SUBJECT: R.E. Ginna Nuclear Power Plant
Docket No. 50-244

Third Supplemental Response to NRC Generic Letter 2004-002, "Potential Impact of Debris Blockage on Emergency Recirculation During Design Basis Accidents at Pressurized-Water Reactors"

REGNPP GL 2004-02 THIRD SUPPLEMENTAL RAI RESPONSE

Figure 15.1: Ginna Strainer Head Loss Test 1 Results

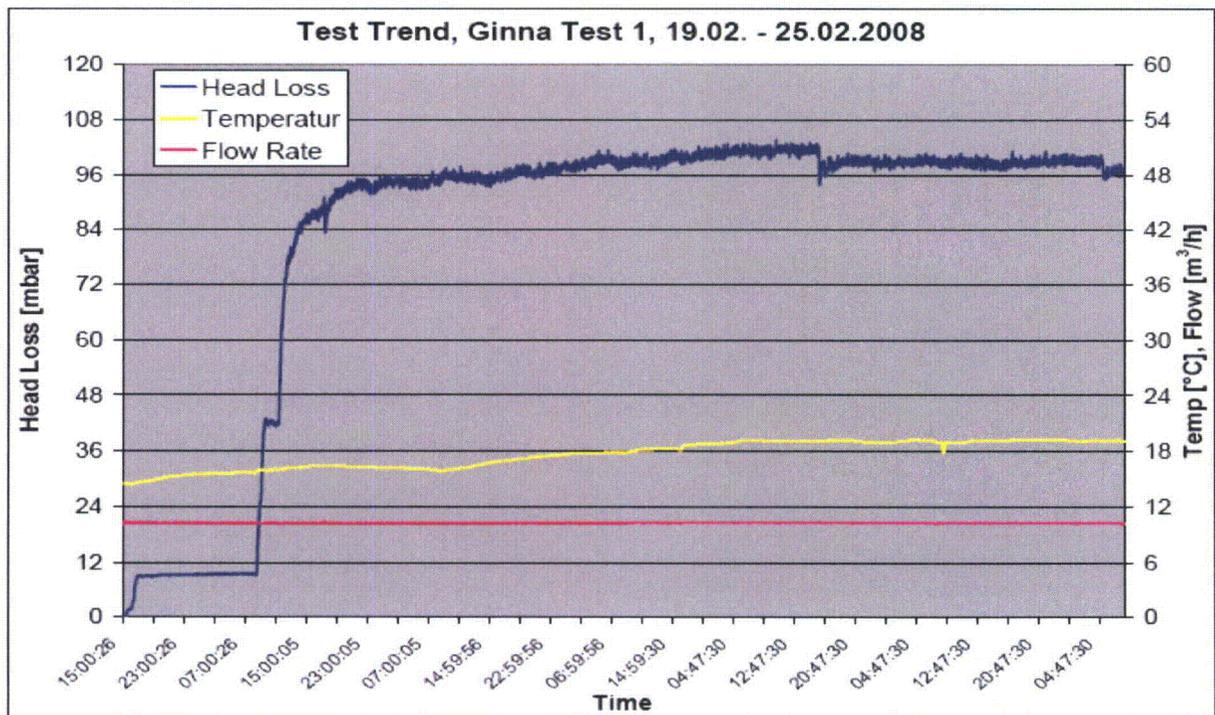
RAI-15: *Please provide the following information as discussed in Enclosure 3 to a letter from the NRC to NEI dated March 28, 2008 (ADAMS Accession No. ML080380214). Specifically, please provide the information requested by item 16.d on page 20 (termination criteria) and items 17.d.i and 17.d.ii on page 21 (test pressure drop curve and an explanation of any extrapolation of data).*

During strainer head loss testing, head loss values were taken every 30 seconds. As can be seen in the Test 1 plot of strainer head loss values (Figure 15.1), the head loss was stable for nearly 2 days prior to the termination of the test. The head loss during this time had minimal variation (± 2 mbar) and the overall trend was steady, to trending down. As a result, it was determined that the maximum strainer head loss had been achieved and no extrapolation of head loss data was performed. The maximum head loss achieved during the test, adjusted for test tank fluid temperature variations and normalized to 20 °C, was 95.2 mbar [15.4]. Since this head loss was the maximum achieved and since subsequent head loss measurements were lower and stable, to trending down, 95.2 mbar at 20 °C was taken as the maximum sump strainer head loss due to debris on the strainer. This value is equivalent to 29.7 mbar (0.99 ft WC) corrected to the minimum containment recirculation pool design temperature of 195 °F.

Figure 19.1: “Train “A” Failure”

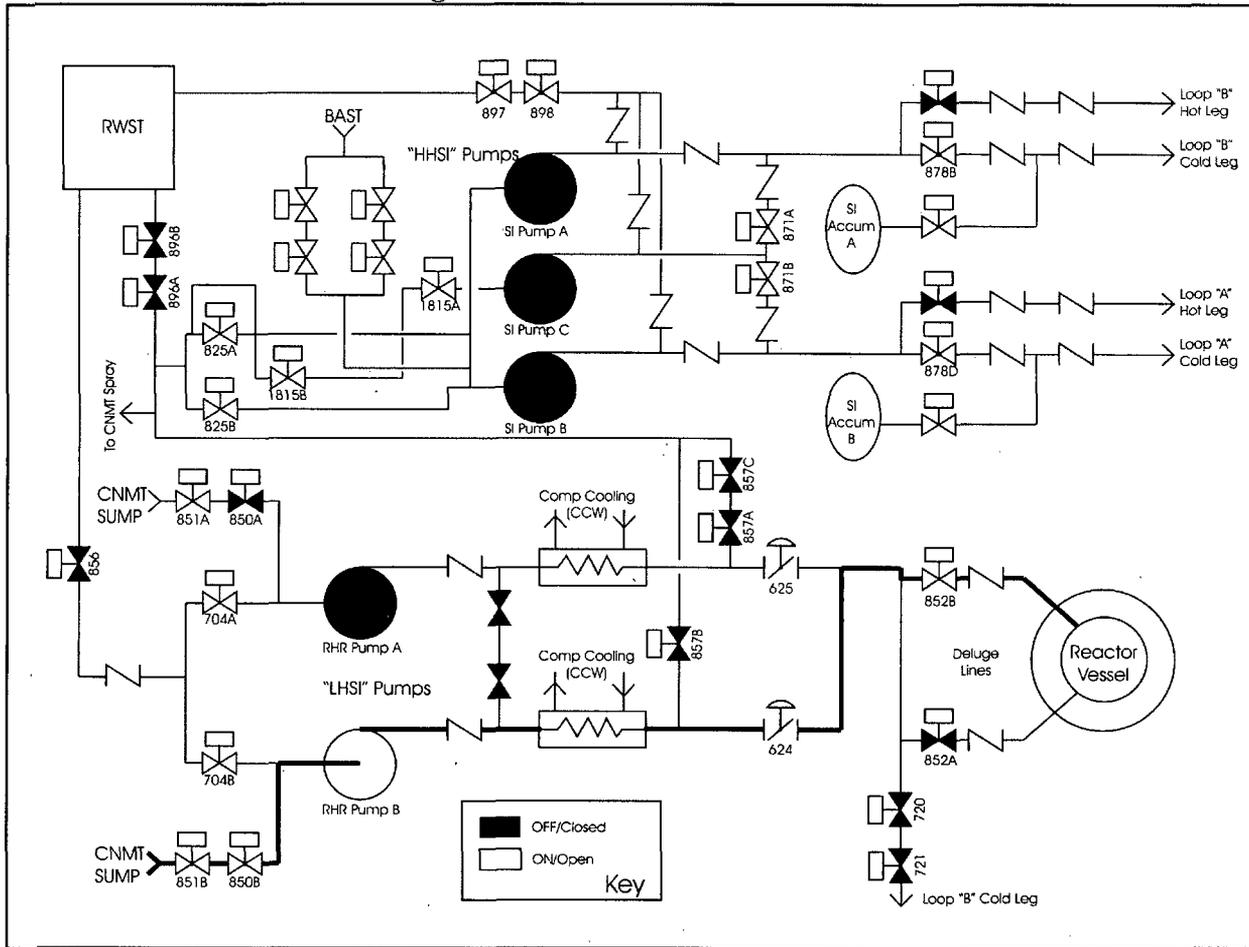
RAI-19: Please provide information that illustrates why there is a difference in the NPSH margin results for the case where “B” RHR pump is operating with a suction line failure (“Suction Line Fails to Open” case) and the case where the “B” RHR pump is operating with a failure of Train A (“Train A Failure” case).

RAI-19 Response: The difference in the NPSH margin between the “Suction Line Failure” case and the “Train “A” Failure” case lies in the difference in system configuration. The “Train “A” Failure” case has a system configuration that provides more flow resistance to the operation of the “B” RHR pump than the “Suction Line Failure” case. Figure 19.1 shows the configuration for the “Train “A” Failure” case. The “Train “A” Failure” case results in the failure of the RHR “A” sump valve (850A) to open, the “A” RHR pump to start, and the “A” deluge valve to open. For the “Suction Line Failure” case, only the RHR “A” sump valve (850A) will fail to open.

From Figure 19.1, it can be seen that the “B” RHR pump provides flow through only one of the deluge lines when Train “A” fails. However, for the case in which one suction line valve (from the sump) fails to open, the operating RHR pump is providing flow through both deluge lines (see Figure 19.2 below).
